DESCRIZIONE: ADAPTER,CONNECTOR DIN43650-C FROM 9.4mm MALE TO 8mm FEMALE

CODICE: CP1-CBP2

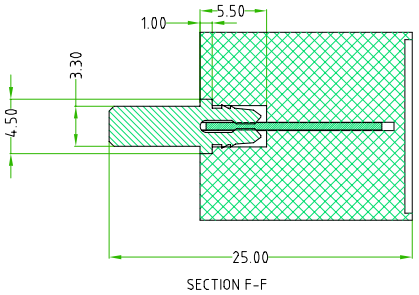
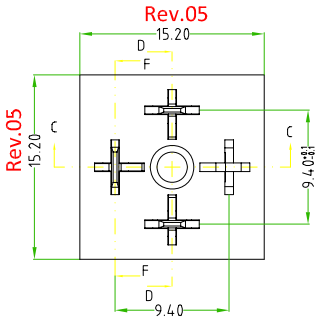
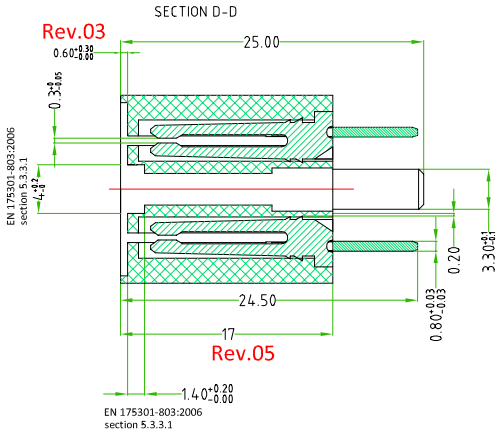
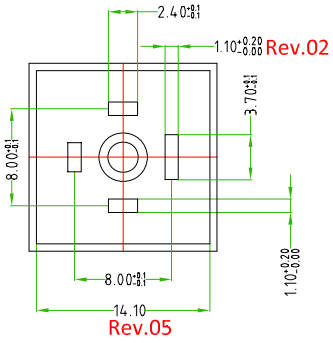
DATE	REV.	DESCRIPTION	SIGNED
06.09.2010	01	Changed the lenght of the adapter from 21mm to 17.5mm	Marco Mazzolini
04.11.2010	02	Changed the diameter of the screw M3x0.5 from 4mm to 3.90mm, increased the width of the holes of the contacts female from 0.8mm to 1.1mm and increased the lenght of the fixing screw from 2.9 to 3.3mm	Marco Mazzolini
08.11.2010	03	Added dimension 0.6mm referring to depth of internal core.	Marco Mazzolini
13.05.2011	04	Cutted the contacts and decreased the hole of the fixing screw from 4mm to 3.8mm	Marco Mazzolini
13.06.2011	05	improved the dimensions	Marco Mazzolini
07.11.2011	06	changed the fixing screw dimension from M2,5X0.5-6g TO M2,5X0.45-6g	Lorenzo Cimmino
13.07.2012	07	The fixing screw must be in STAINLESS STEEL AISI304 Apply N°1 NBR PROFILED GASKET	Lorenzo Cimmino
